Order Number:	CPO 0211 4001 GSD2100000024 4	Procurement Folder:	865195
Document Name:	N Portico Stairs-Failing Concrete Slab Assessment & Design	Reason for Modification:	Change Order 2
Document Description:	N Portico Stairs-Failing Concrete Slab Assessment & Design		To increase and extend the contract.
Procurement Type:	Central Purchase Order		
Buyer Name:	Melissa Pettrey		
Telephone:	(304) 558-0094		
Email:	melissa.k.pettrey@wv.gov		
Shipping Method:	Best Way	Effective Start Date:	2021-03-29
Free on Board:	FOB Dest, Freight Prepaid	Effective End Date:	2024-05-31

**To:** Melissa Pettrey, Senior Buyer, WV Purchasing Division  
**From:** James Jones, Procurement Administrator, General Services Division *James R Jones*  
**Date:** December 27, 2022  
**Ref:** Change Order # 2 - CPO GSD2100000024 - North Portico Stairs Project

Reference:    West Virginia State Capitol: North Stair Repair  
                    Additional Design and Construction Phase Services  
                    WDP Project No. 21060

**Photograph 1. Example of damage and deteriorated patches at a portico column**

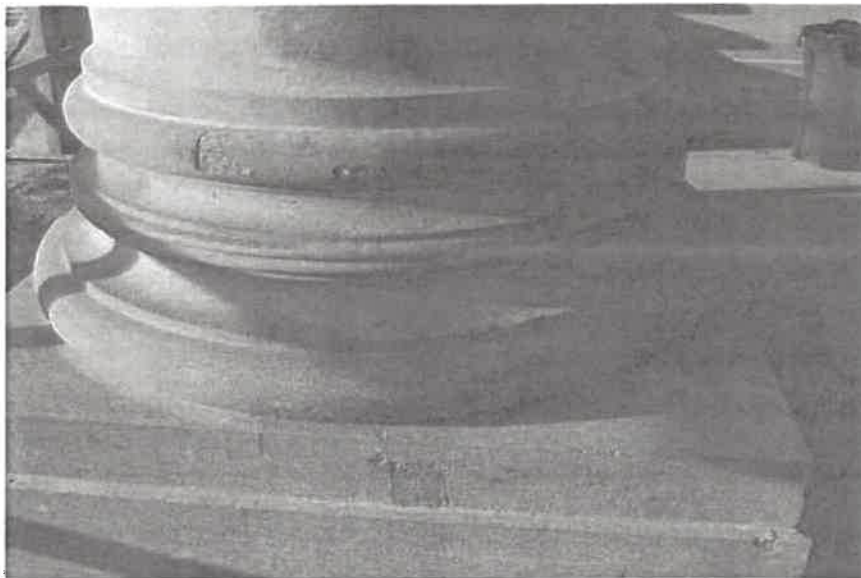
- New interior finishes, mechanical, electrical, and lighting will be installed within the occupied spaces beneath the North Stair.
- Temporary weather protection measures will be installed within the interior spaces beneath the North Stair in lieu of providing a temporary enclosure structure over the North Stair.
- Damage was observed at many of the cheek wall stones and portico column bases that were not indicated to be removed during the phase-1 project

(Photograph 1). Additional stone repairs will be performed at the remaining cheek wall stones and portico column bases to prevent further deterioration and damage to these elements.
